Exhibit U-1

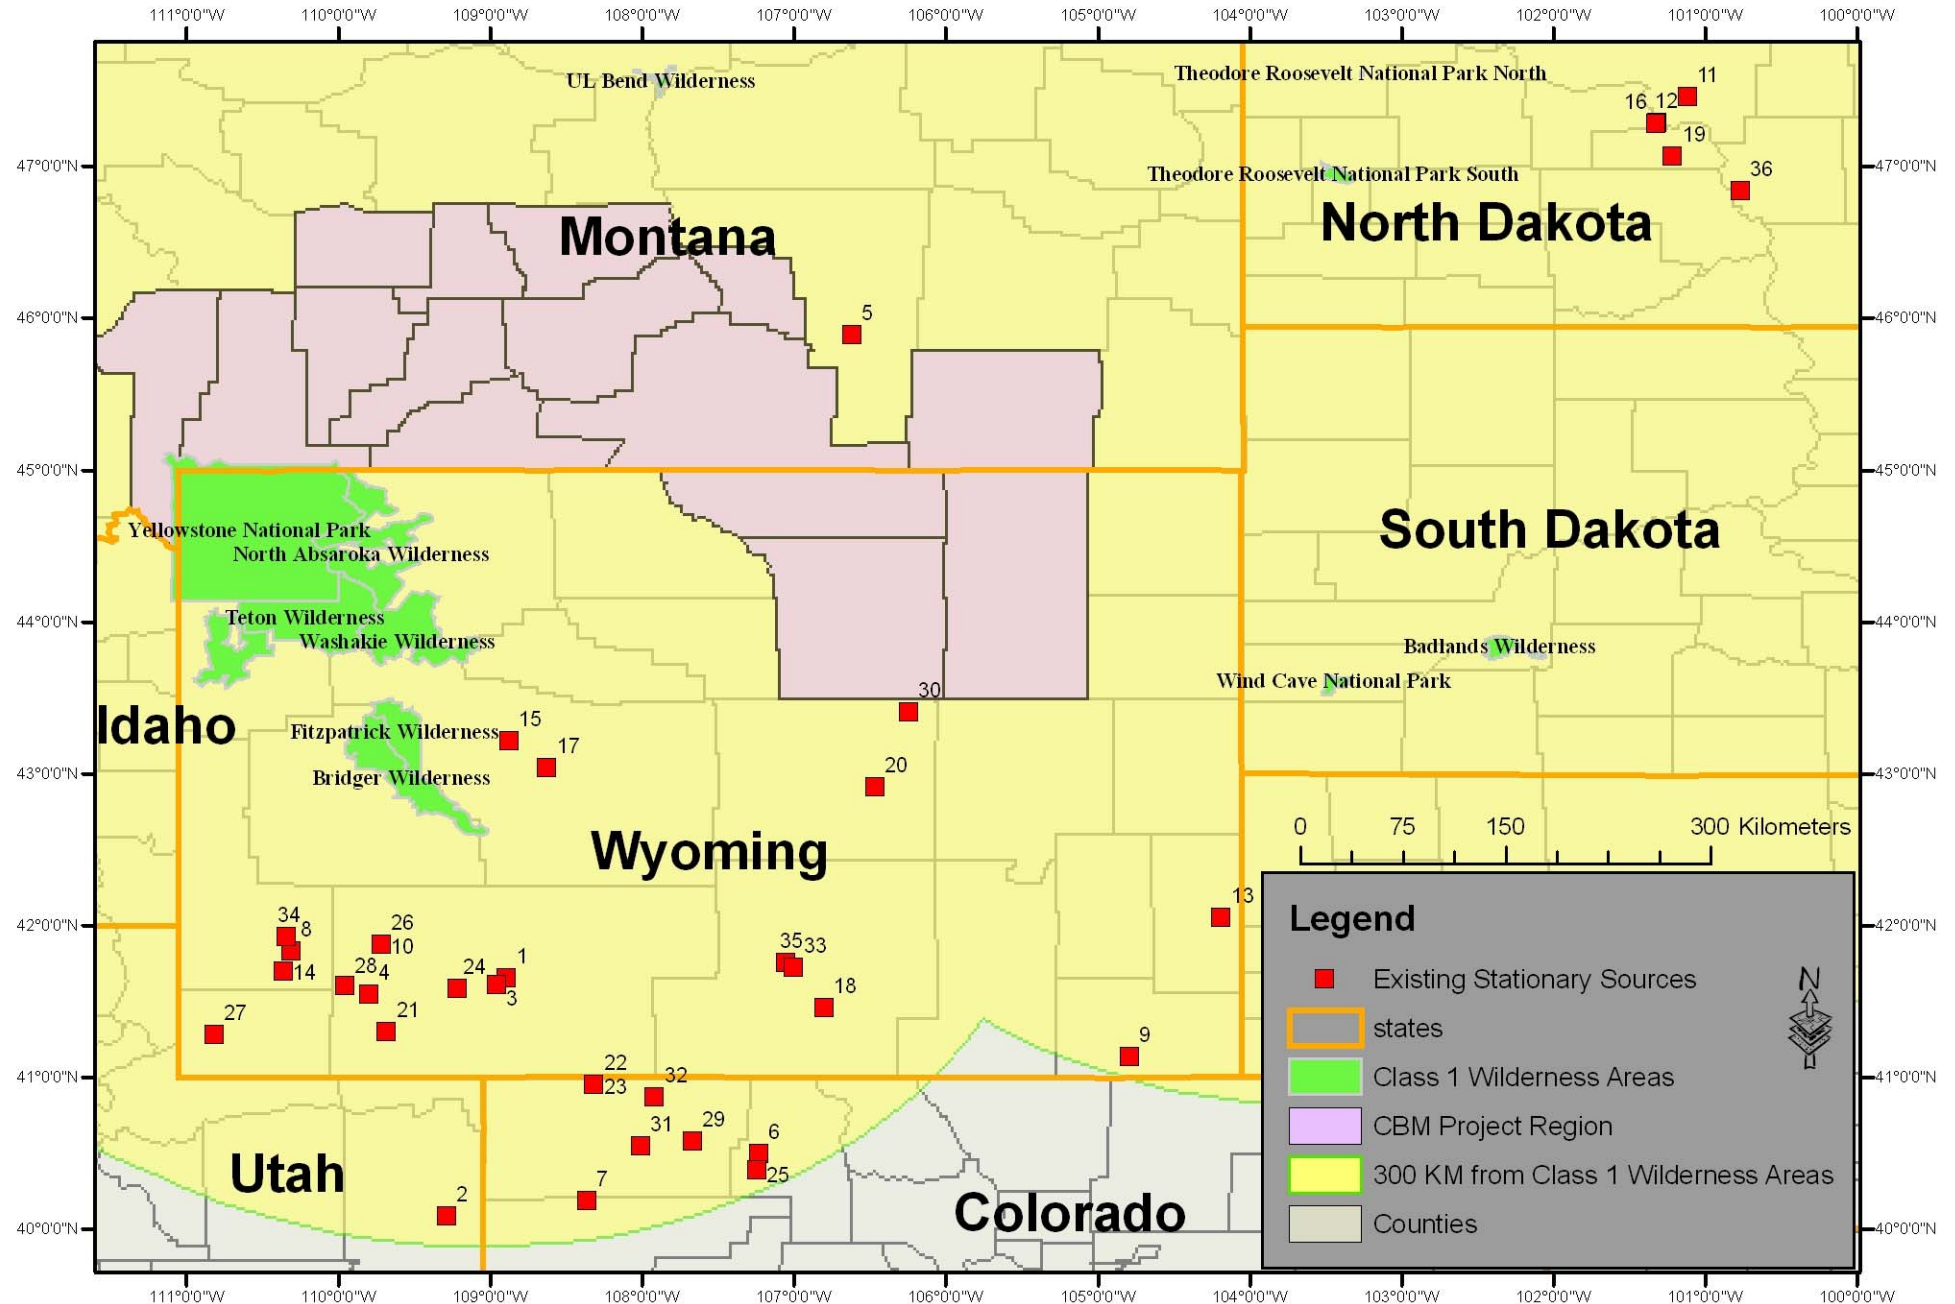
Major Stationary Emission Sources Omitted from Modeling Analysis of Cumulative Emissions Impacts on Class I Areas
